SP AusNet Submission re Metrology Harmonisation *Rules* Changes

4 SP AusNet Comments with Respect to Specific *Rules* Clauses

Schedule 7.1 - Responsibility for Metering{ XE “metering” }

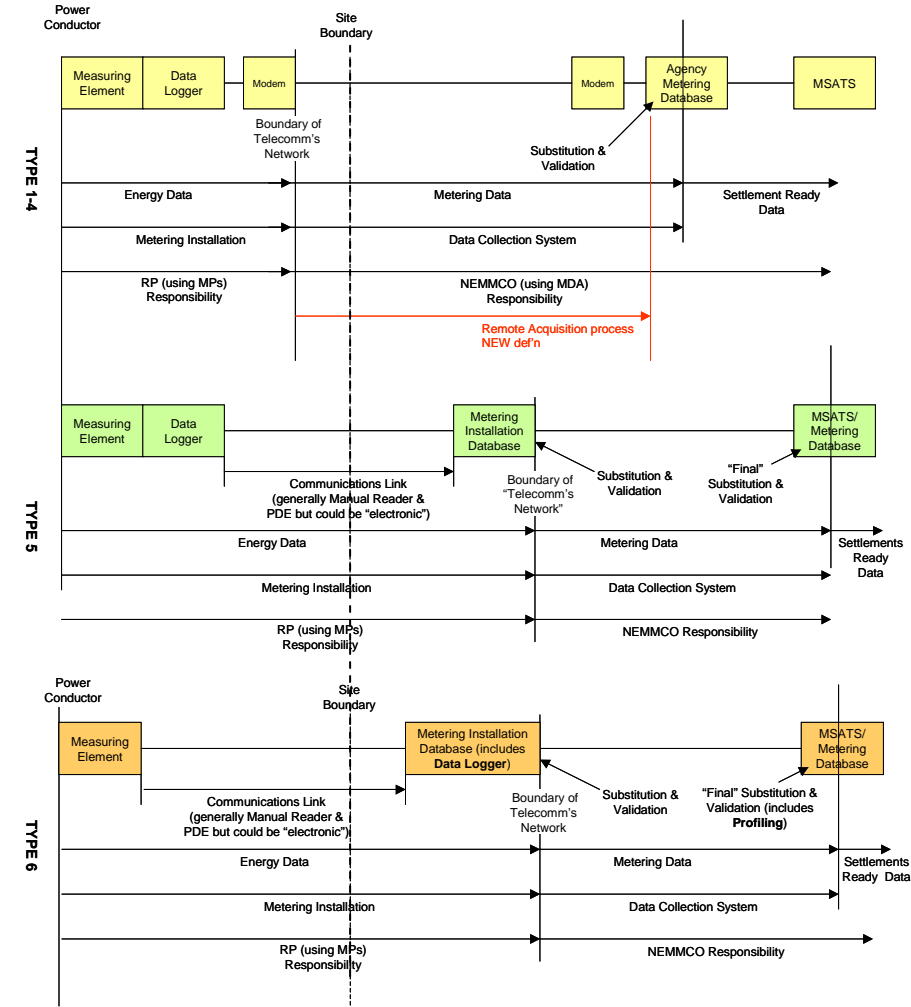
Item 31 Schedule 7.1

Although this diagram in the New Rules has been revised to improve it as an aid to understanding definition and interfaces, it is still short of the detail required for industry personnel to deal with and interpret the current Rules wording. Refer SP AusNet Item 13 for further comments on the need for wording change.

SP AusNet consider that the diagram below or similar provides a better aid to understanding.

Whilst this diagram may be slightly less general in its application it is considered by SP AusNet to be significantly more relevant and applicable to the majority of Participant relationships and situations.
